### PIP5706A Rough Running, Reduce Engine Power, Service Engine Soon (SES) light on, P0123 and P0222

Product Investigation Review Required

Brand:	Model:	Model Years:	VIN:		Engine:	Transmissions:
			from	to		
Chevrolet	Silverado 2500/3500	2020 - 2021	All	All	6.6L L8T	All
GMC	Sierra 2500/3500	2020 - 2021	All	All	6.6L L8T	All

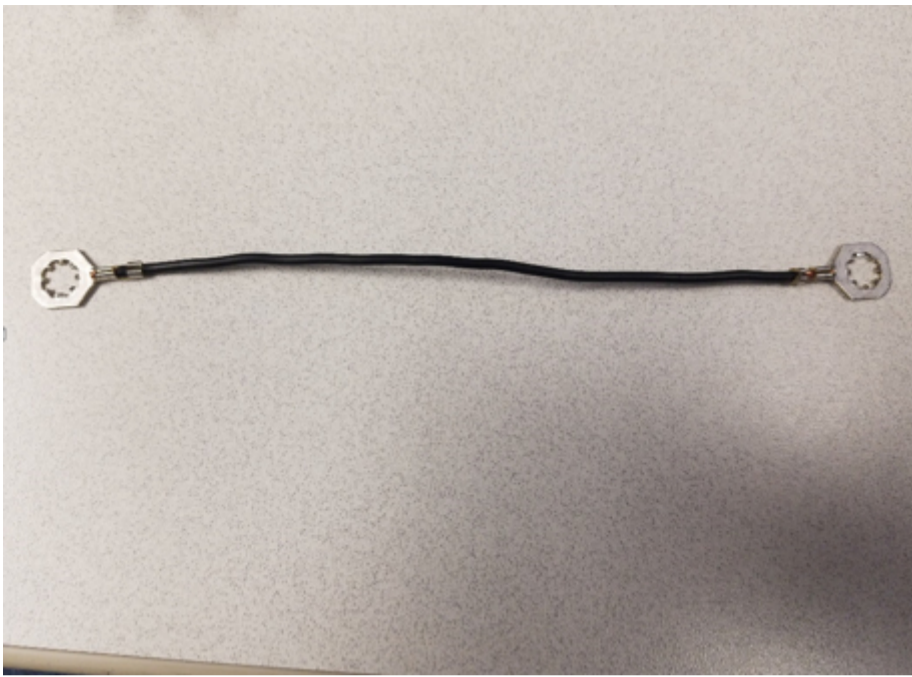
If you encounter a vehicle with the above concern, it will be necessary to replace the throttle body and add a ground wire following the steps outlined below . Reference the attached pictures showing ground wire location.

- 1. Replace throttle body following the service procedure as outlined in service information.**
- 2. Using two 8mm ring terminals and one 8-inch piece of wire 14-gauge wire to make a ground wire as shown below:**

**4. Attach one end of the ground wire to the lower right throttle body fastener with the crimp side of the ring terminal facing towards the bolt head:**

**5. Attach the other end of the ground wire to the rocker cover fastener as shown in picture below with the crimp side of the ring terminal facing towards the bolt head:**

**6. When procedure is complete the ground wire should look like the installed wire below:**
